762 & 764 VALLEY COURT

YARD EXPANSION FOR 84 LUMBER

SUBJECT: Response to Comments – 84 Lumber Yard
Expansion (SPR-2003-075).

84 LUMBER YARD EXPANSION
SITE PLAN

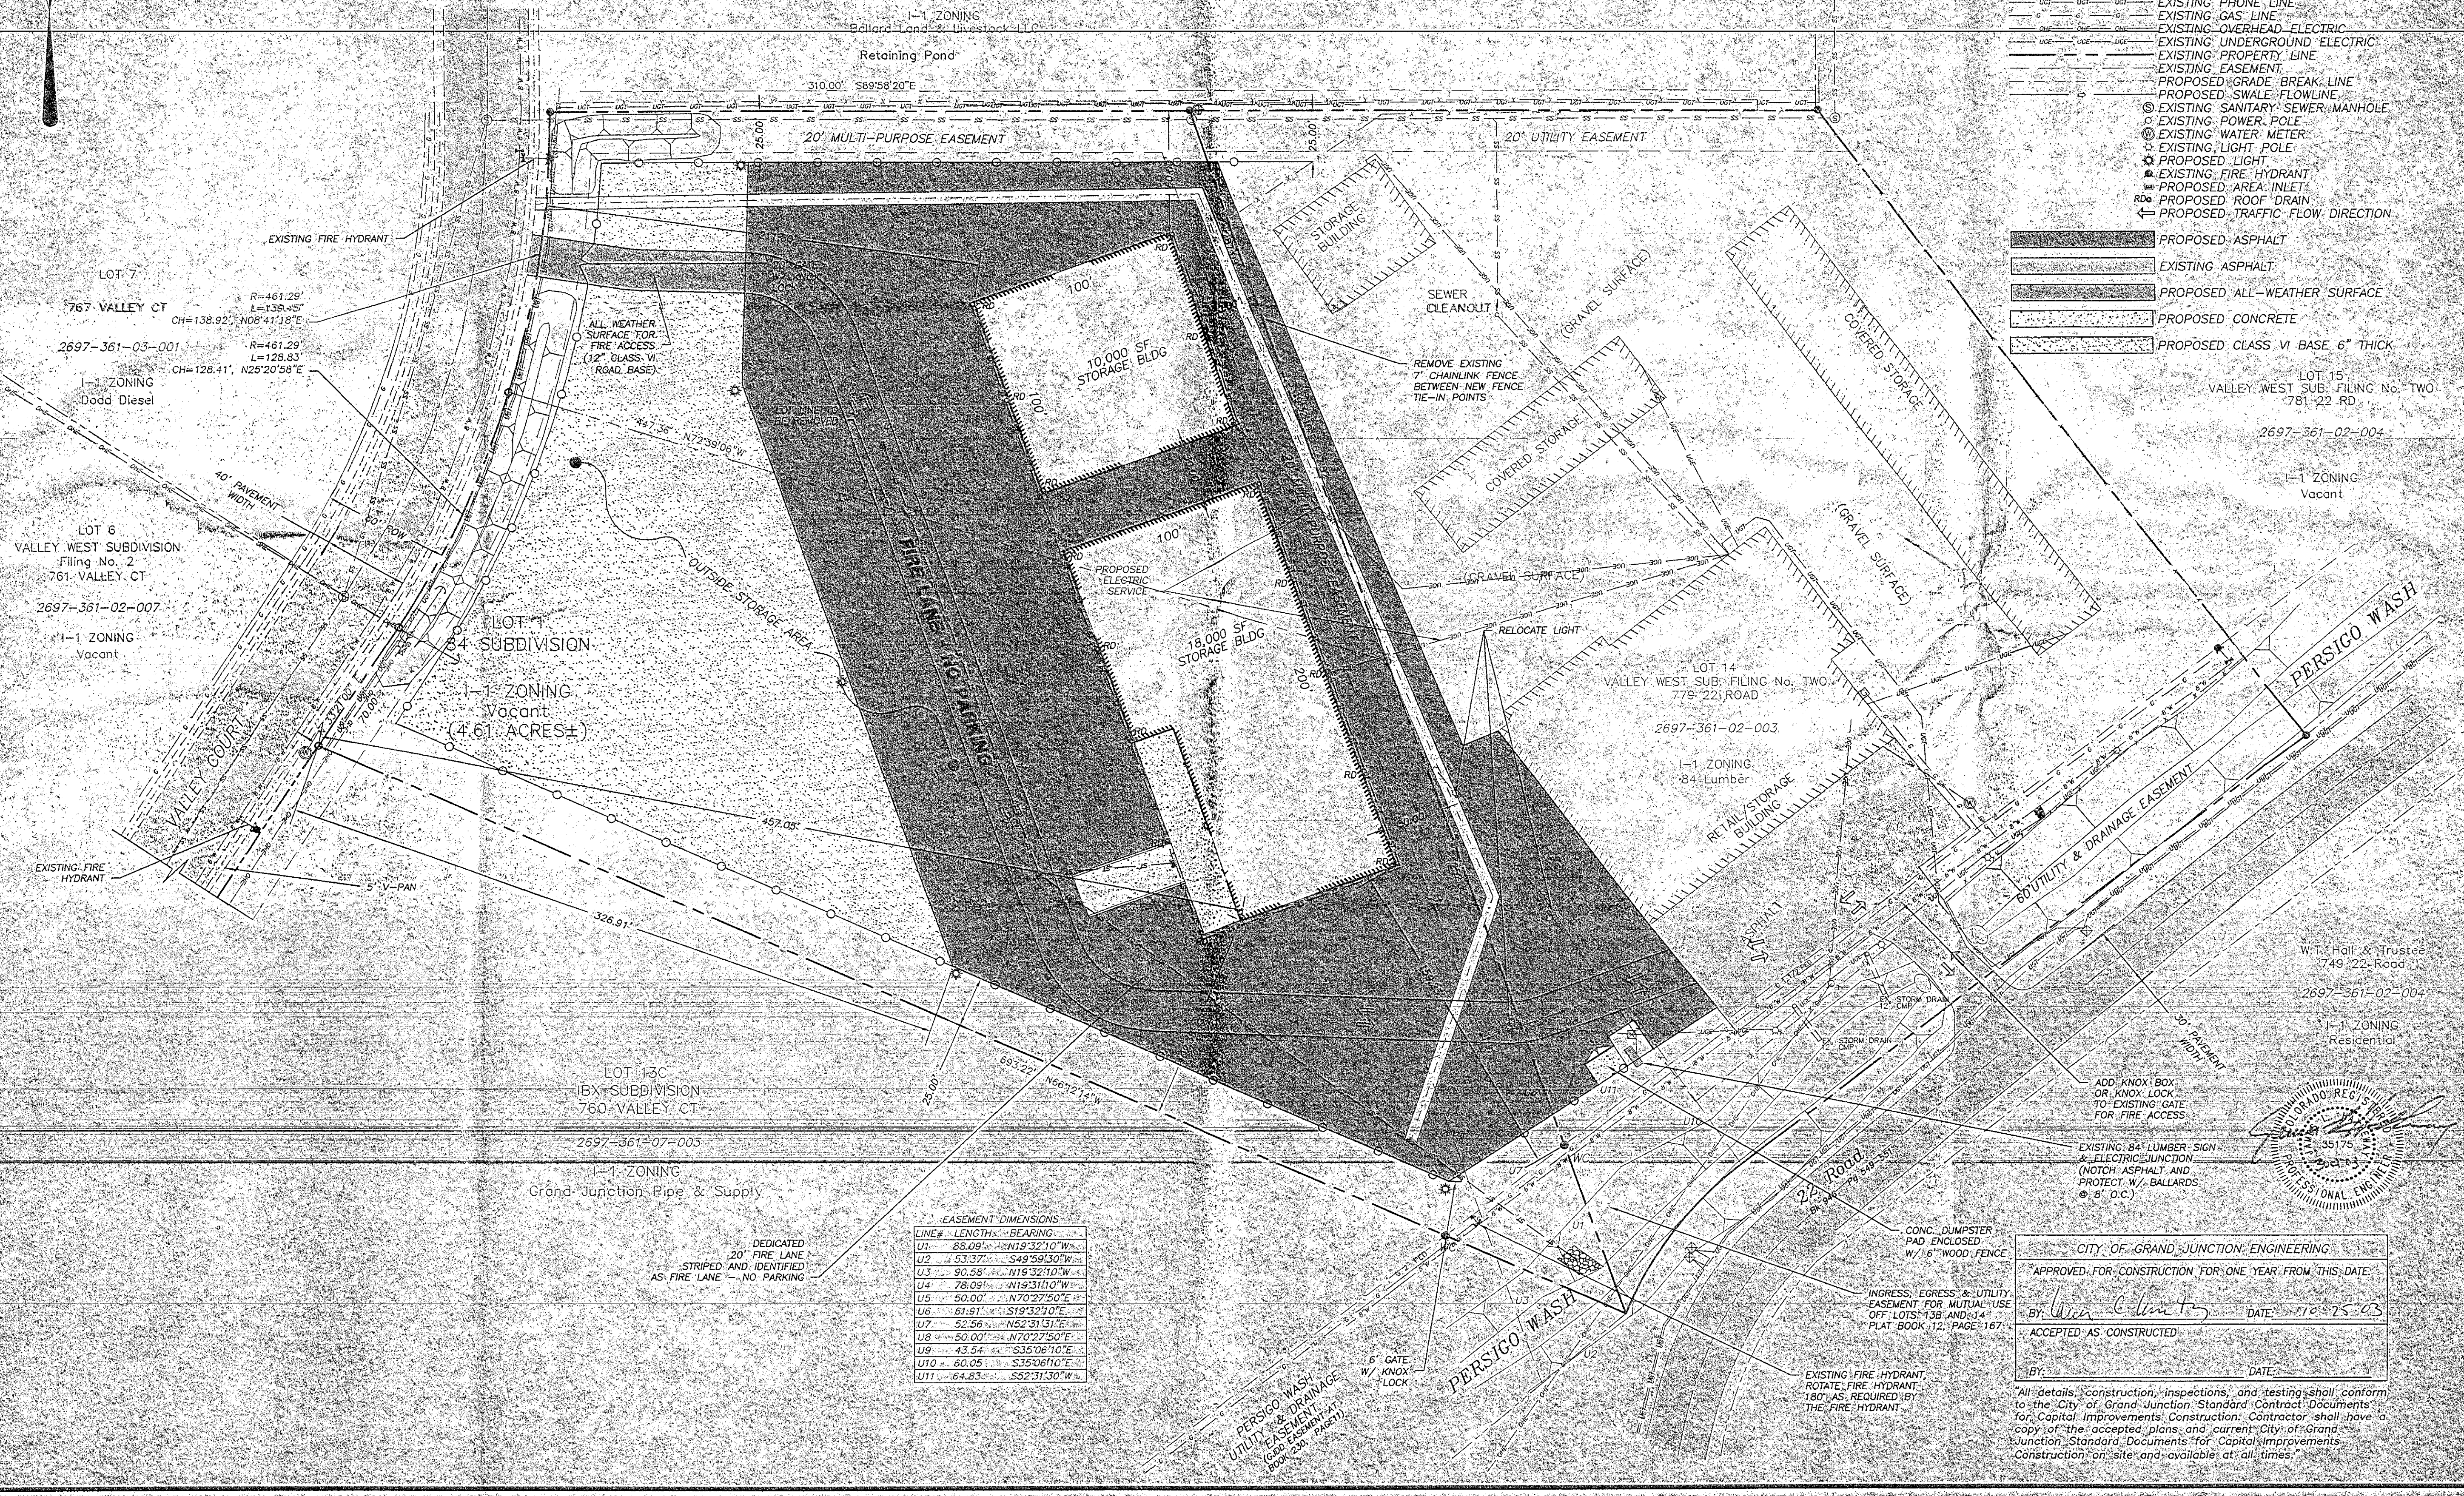
2. Sht SP 1: If access on Valley Court is strictly for fire and gate remains locked and not used for deliveries, employee entrance or other operations, provide allweather surface on required radii. Otherwise bring access and "fire lane" up to access standard in TEDS for commercial access. Show opposite and adjacent access points within 150'.

Response: The access from Valley Court is for emergency vehicle access only. The access is called out as Class VI Road Base to serve as the all-weather surface. All radii meet the 30' minimum specified in TEDS.
